ADDENDUM NO. 1

Project Name: **Traffic Operations Facility, IRC-2104**

Bid Number: **2023059**

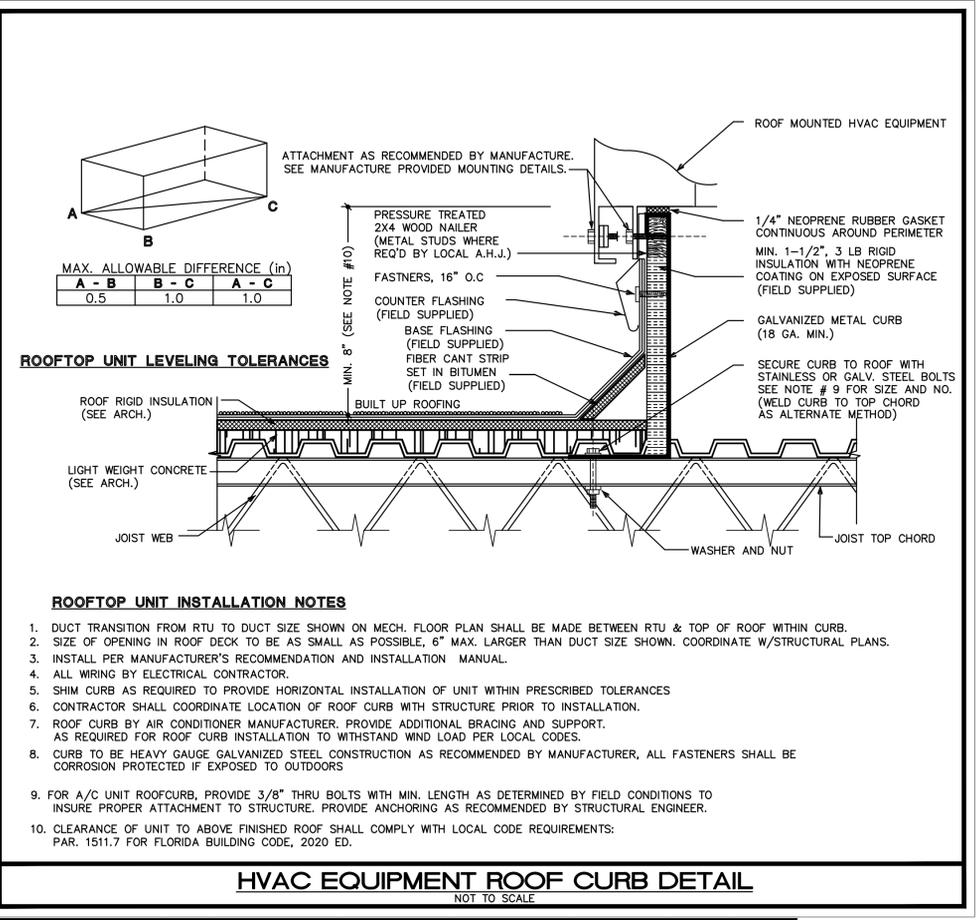
- **Division 2 – Technical Provisions Section 160 – Stabilizing shall be changed:**

Bid Item No. 160-4A Type B Stabilization (Sidewalks and Laydown Area on East Side of Site), 6" Thick
- Per Square Yard

Bid Item No. 160-4B Type B Stabilization (Car Parking and Service Yard Area) 8" Thick – Per Square
Yard

- 160-4A Type B Stabilization for the sidewalk and vehicle areas will be bid as 6” for the sidewalk and 8” for the vehicle areas. (Civil Plan Sheet C2 show revision)
- 515-1-2 Pipe Hand Rail – quantity change from 12’ to 24’
- 711-11-170 Thermoplastic Pavement Markings and Arrows - quantity change from 6 to 7
- 1050-31202 – Utility Pipe - quantity change from 240’ to 75’
- “Plumbing” will be added to Division 15 description

Drawing Title: **MECHANICAL SCHEDULES**

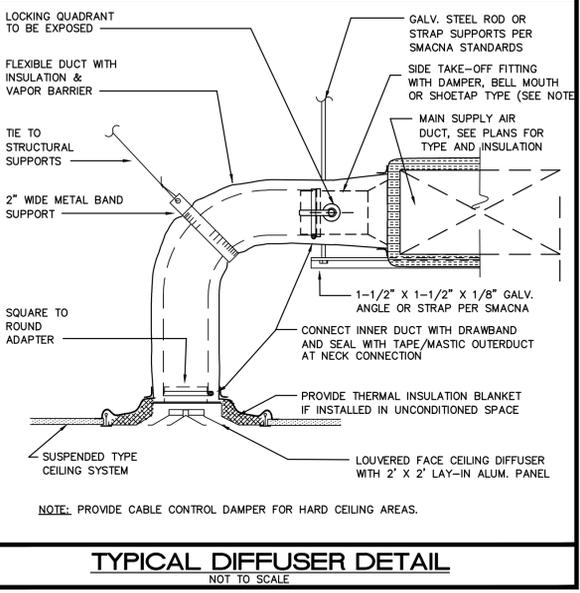
- **Mechanical Sheet M6.1** - has been revised with:

Note 18: Provide Trane Building automated controls for Integration with the County building management system. Contractor to coordinate with County and Manufacturer.

18. PROVIDE TRANE BUILDING AUTOMATED CONTROLS FOR INTEGRATION WITH COUNTY BUILDING MANAGEMENT SYSTEM. CONTRACTOR TO COORDINATE WITH COUNTY AND MANUFACTURER.
